EP YAK 55 3D

TECH NOTICE

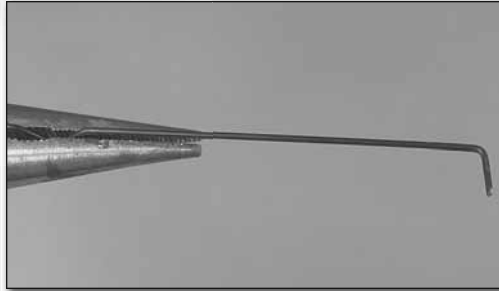
The 90° bends on the control surface pushrods may be improperly bent, preventing connection to the control surfaces. To correct the bends please follow the steps below.

1. Secure the pushrod at the V bend with pliers.
